ADA Curb Ramp New Construction Inspection Form (Combination)

NW Curtis

23885.56

NW Pacific

COMBINATION RAMP (C)

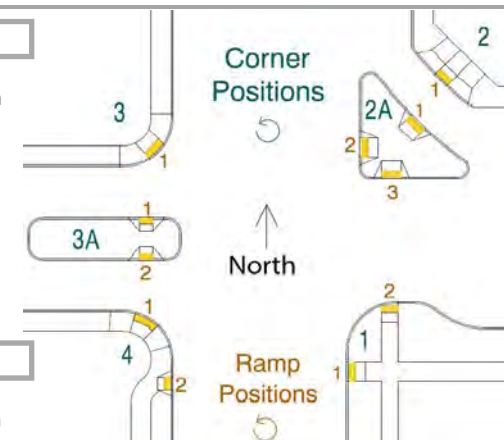
Ramp run 3-crack in walking path
